ITEM	DESCRIPTION	REF. DESIGNATION	
2004-9-15	R.Okano		D	2400352	REV C	SMT 1/1
2004-3-3	H.Funakoshi		AS-1310 : コネクタ寸法図			
2004-1-25	H.Funakoshi					
SCALE	UNIT	TOLERA				
1 : 1	mm	± 0.26	m i s

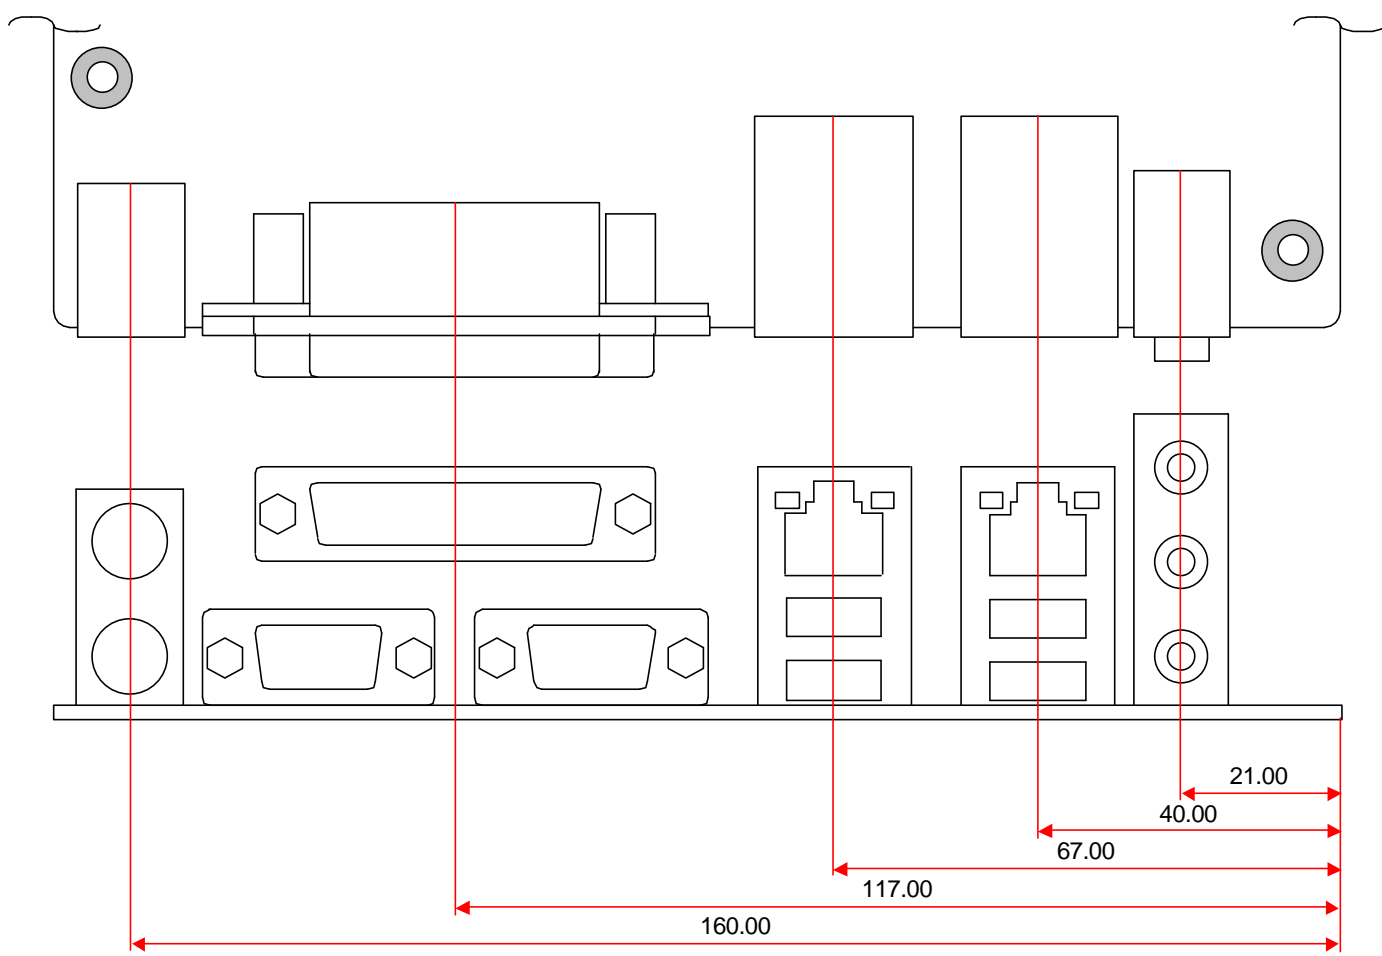
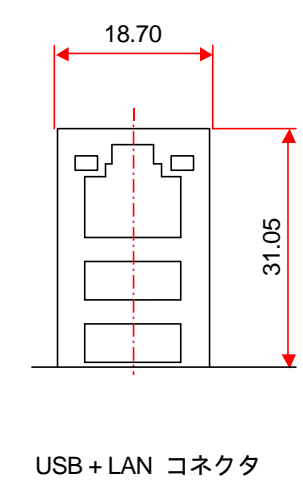
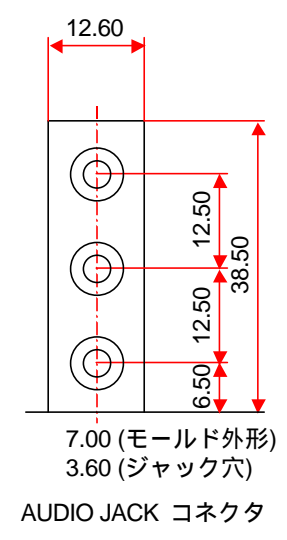
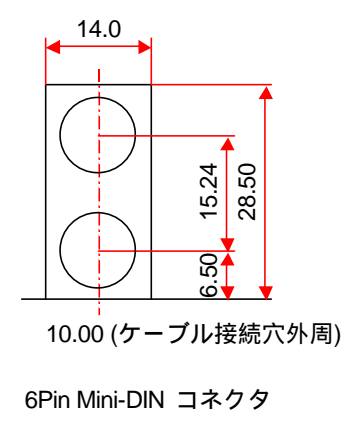
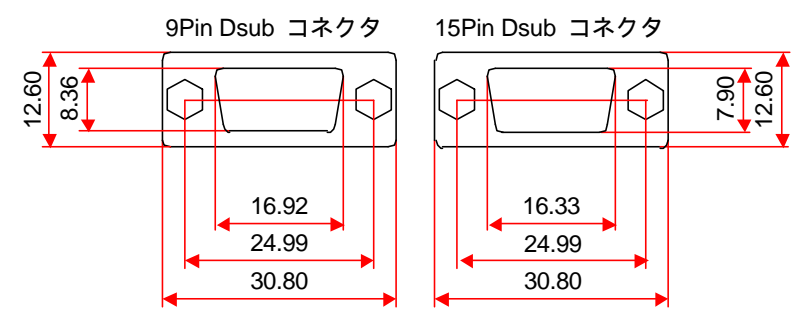
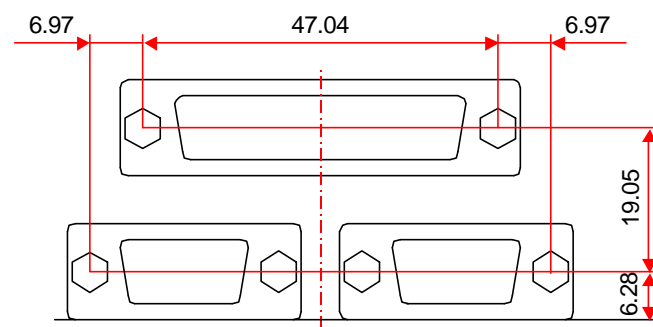
変更履歴
REV.A 初版
REV.B J4 基板配置寸法誤記訂正
177.00 (誤)
117.00 (正)
REV.C J5 : 6Pin Mini-DIN コネクタ横寸法追記
J2, J3 : USB+LAN コネクタ部品変更
